Approval Application or Notification for Changes In and About a Stream

Street Address of Works (or nearest town): <u>Mystic Vale, University of Victoria</u>		
Stream Name: <u>Hobbs Creek</u>	Flows Into: <u>Cadboro' Bay</u>	
Location on Stream: <u>Along creek length of 800 m from Cedar Hill X Rd to Galimberti Pond on UVic property</u>		
Reference Landmarks: <u>Hobbs Creek watershed & Mystic Vale</u>	Amount of disturbance in m ² : <u>20</u>	
Multiple Sites: <u>YES</u>	Number of sites: <u>15</u>	
Latitude: <u>48d 27m 38s</u>	Longitude: <u>-123d 18m 13s</u>	Elevation: <u>23m</u>
Legal description of property where work is proposed: <u>Lot 6, Section 44, Victoria District, Plan 11376 & part of lot 1 Plan 7682</u>

MINISTRY OF ENVIRONMENT – SECTION 9 NOTIFICATION

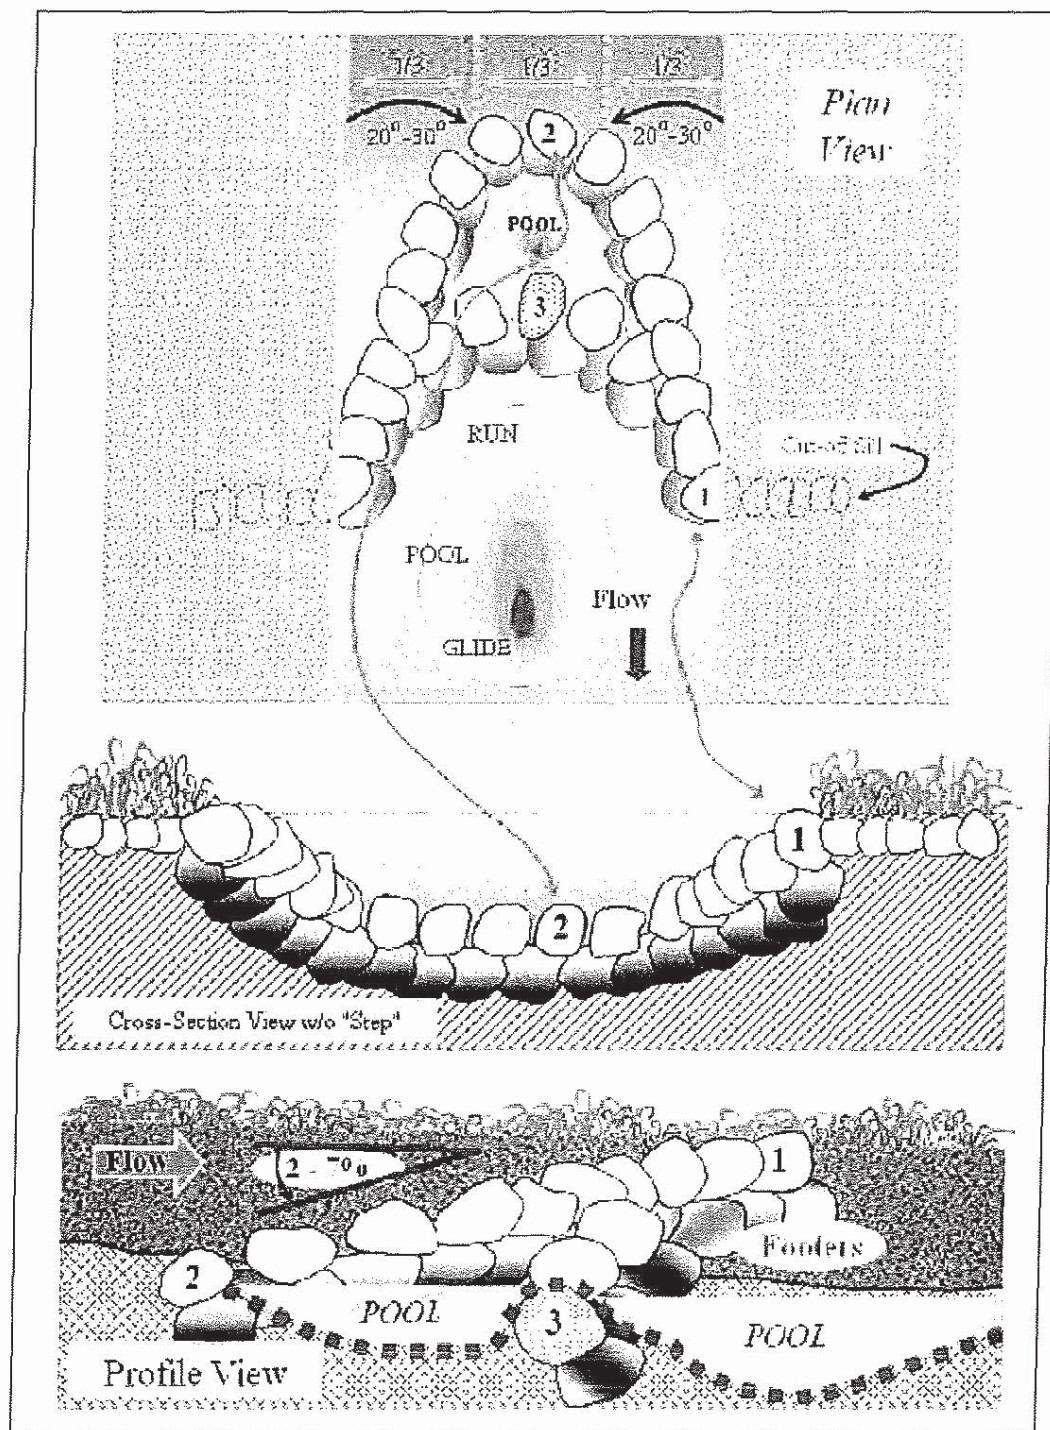
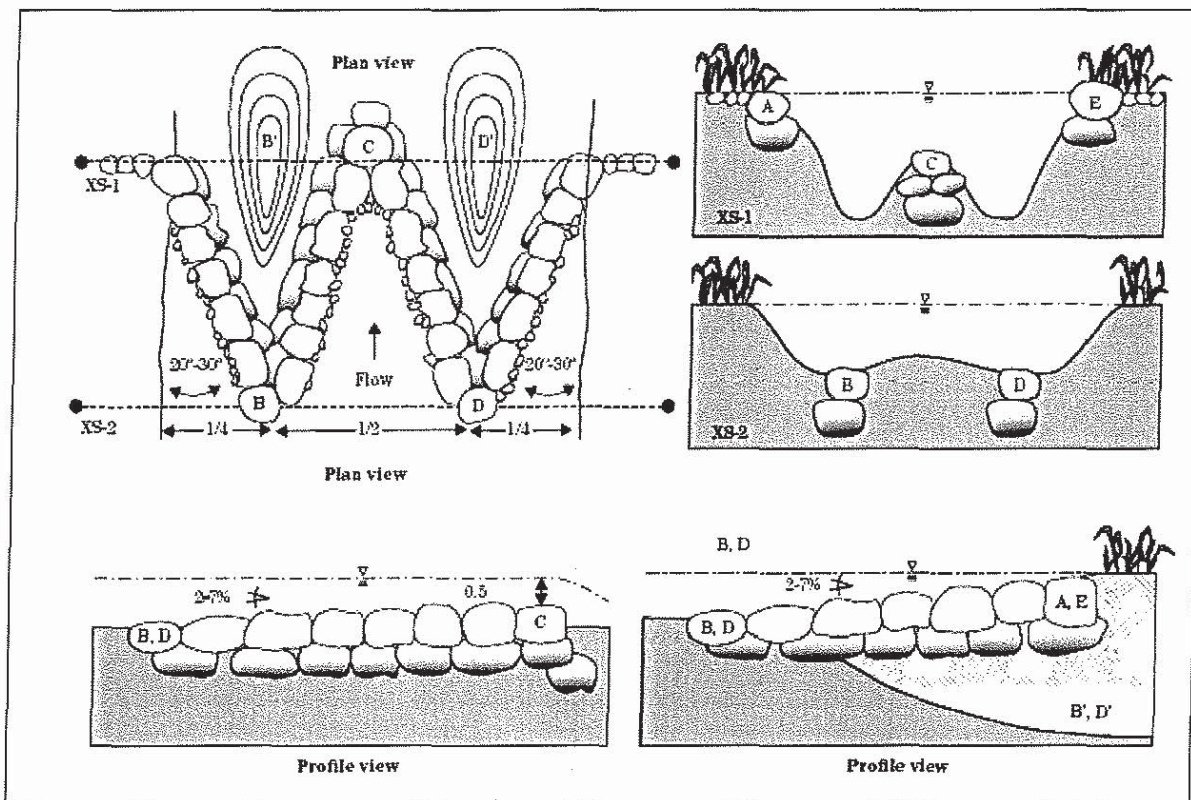
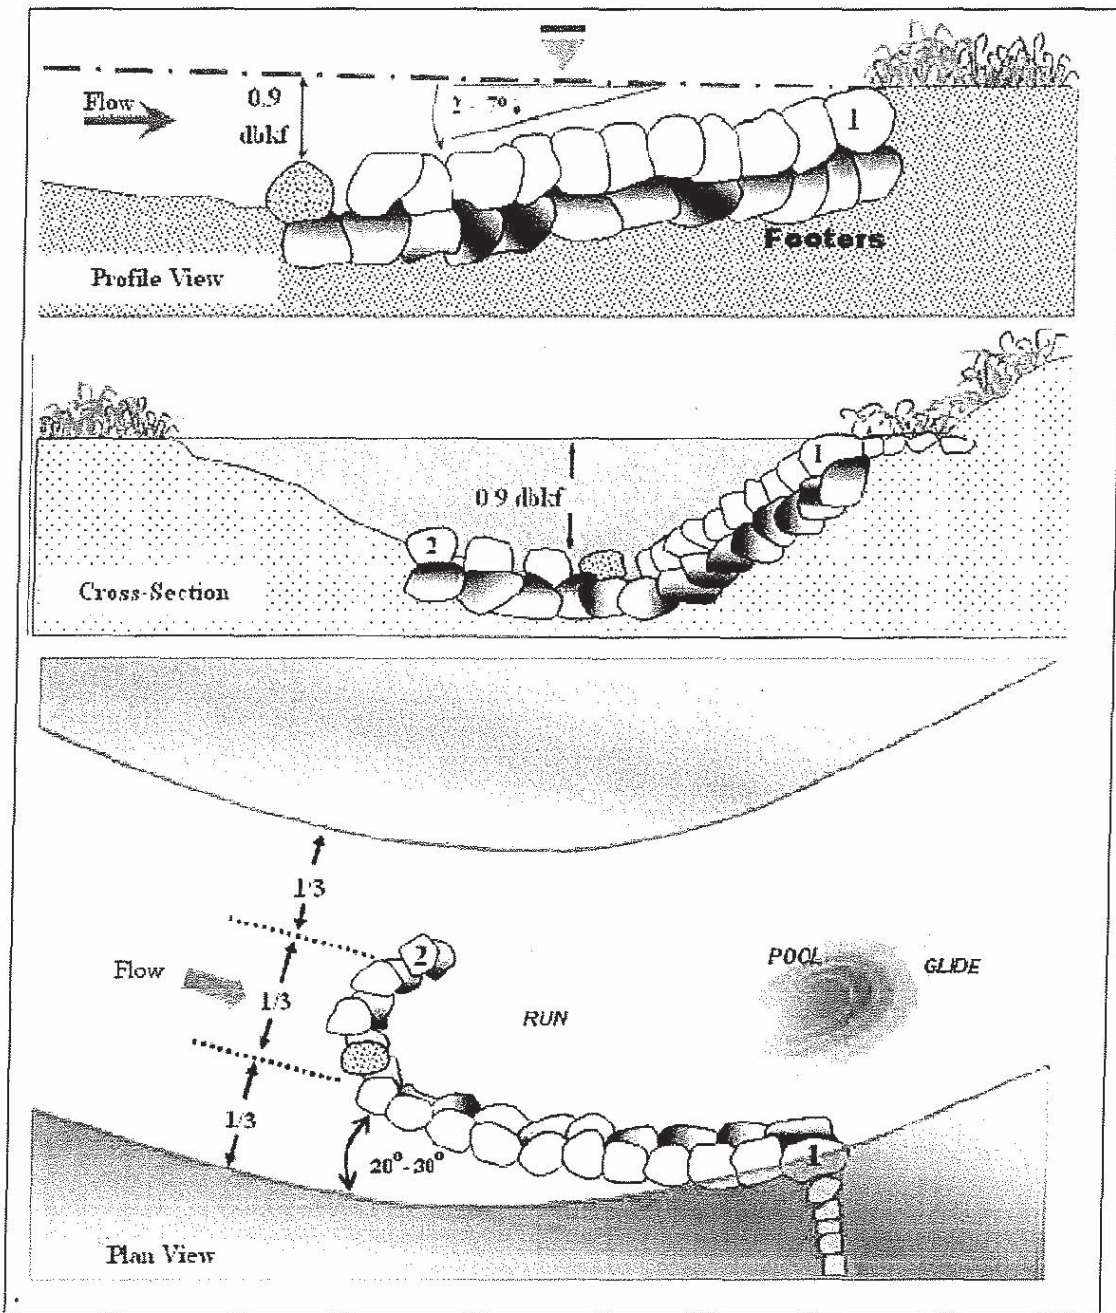
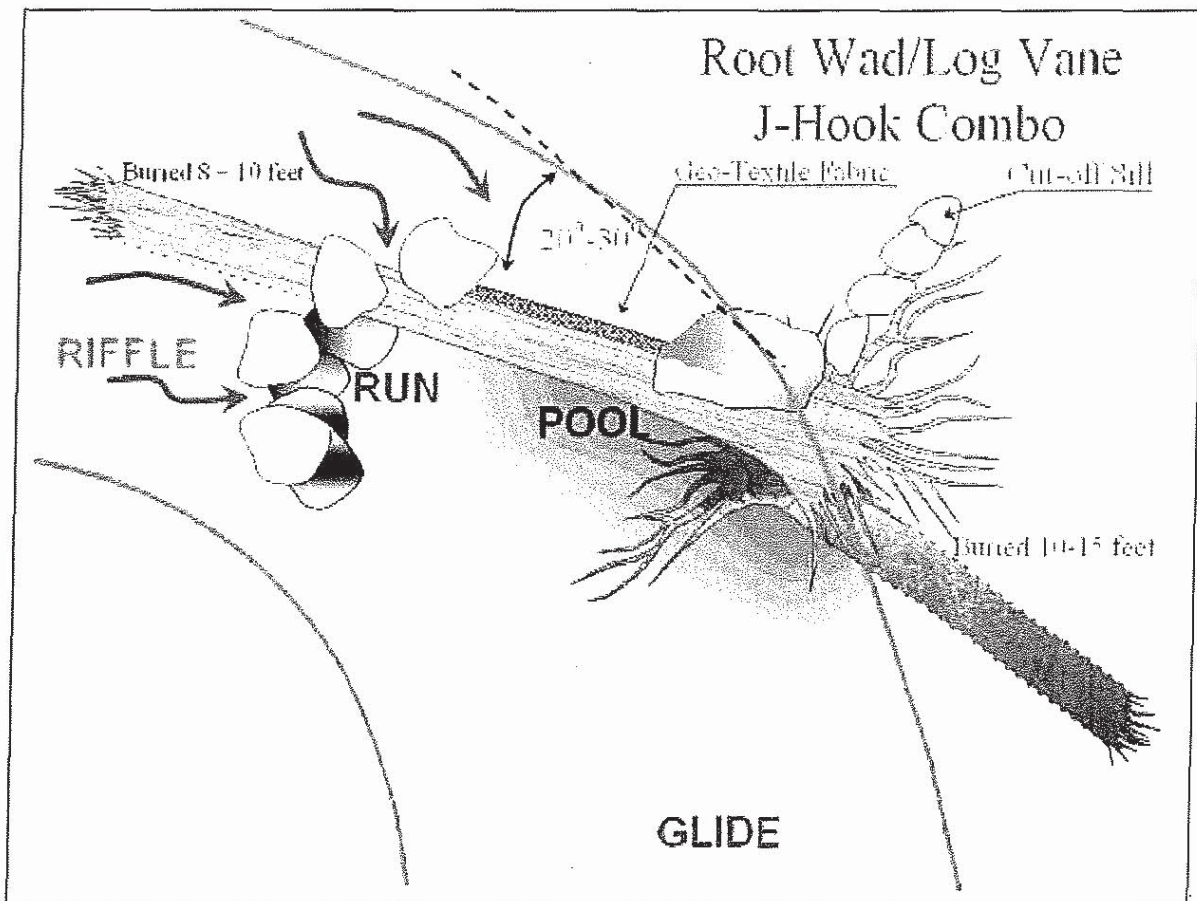
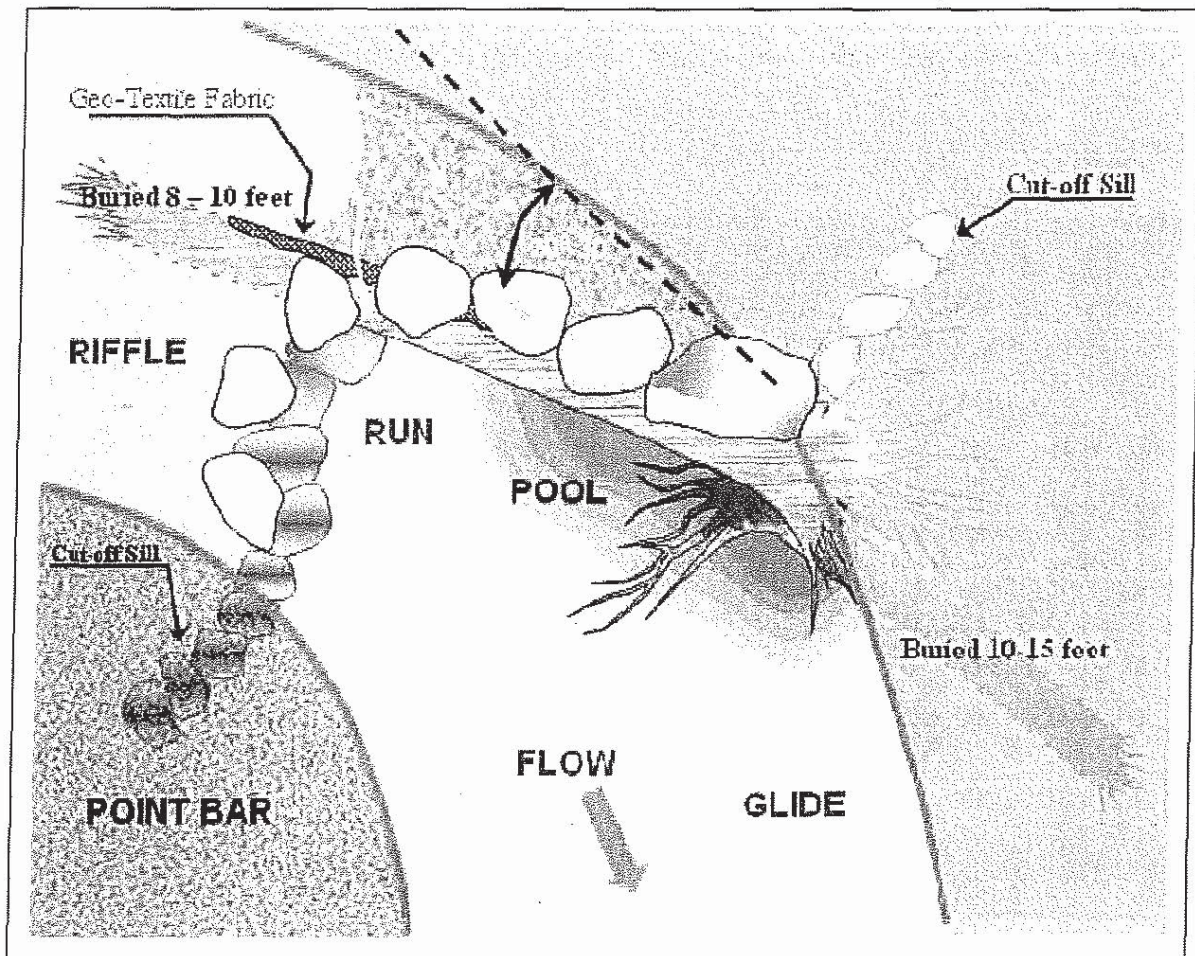
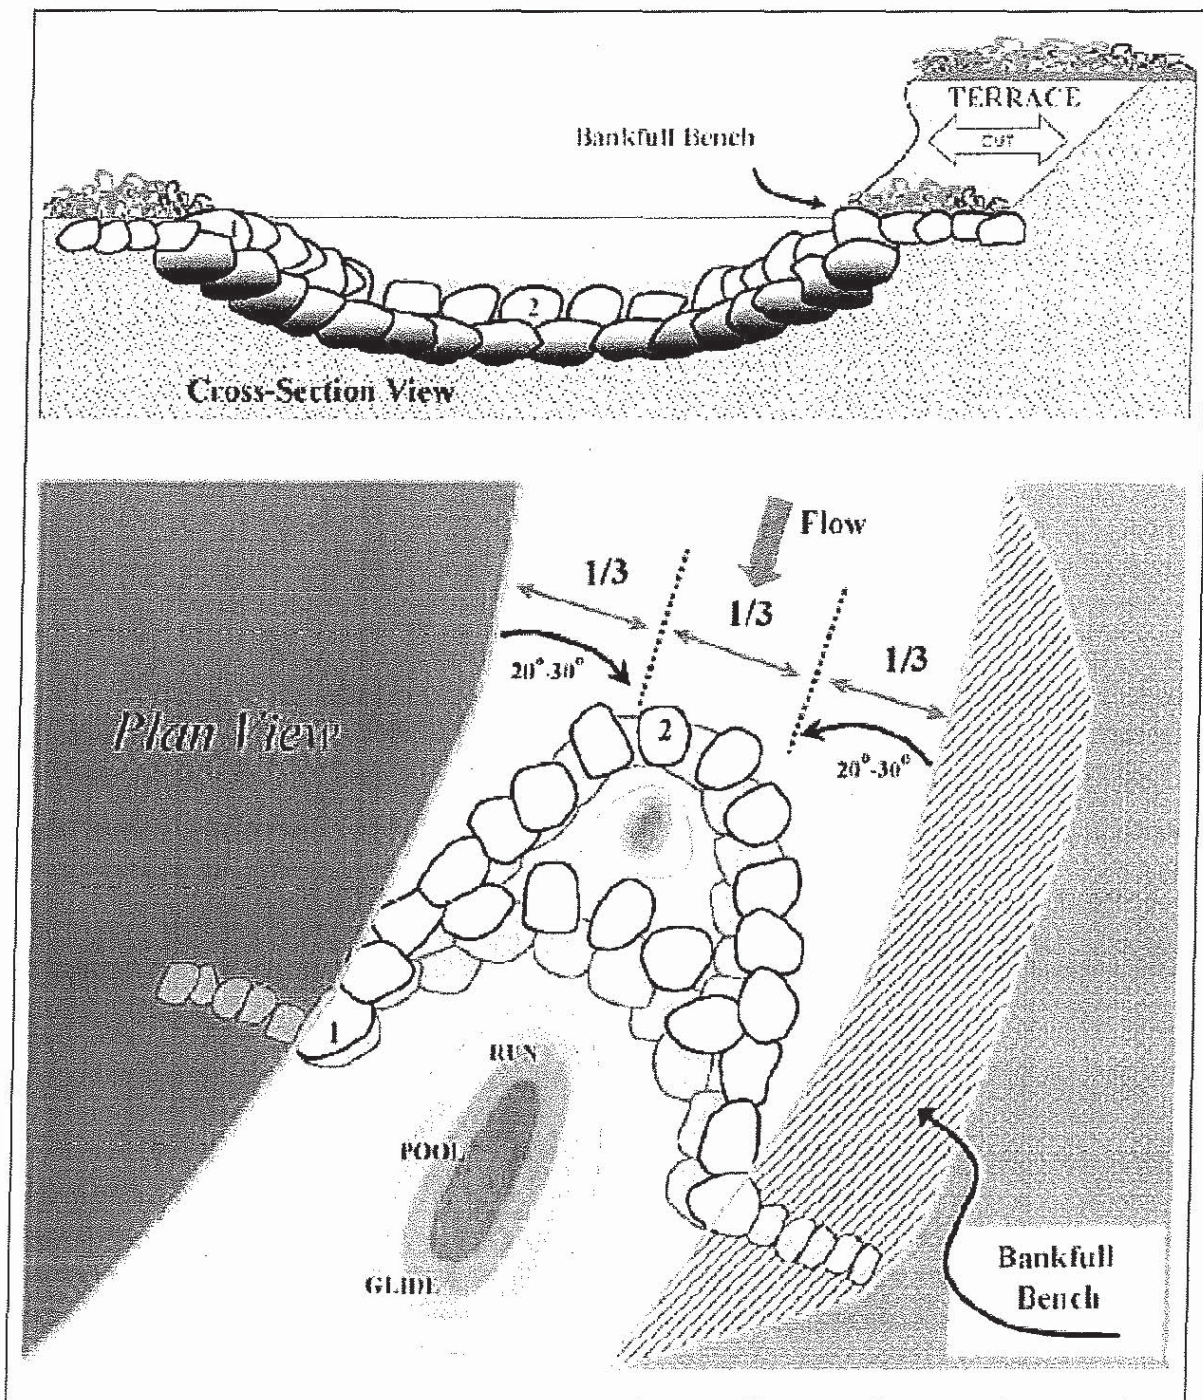
Date	
<u>May 1/09</u>	<i>In reviewing this application I ^{would like to know} am confused by the how many sites will actually be worked on in this area. Figures 11 to 16 seem to reference different sites on Hobbs Creek, and I would like to know which sites will be rehabilitated using which technique (or fig #). Thanks.</i>
<u>July 23/09</u>	<i>- OK.</i>
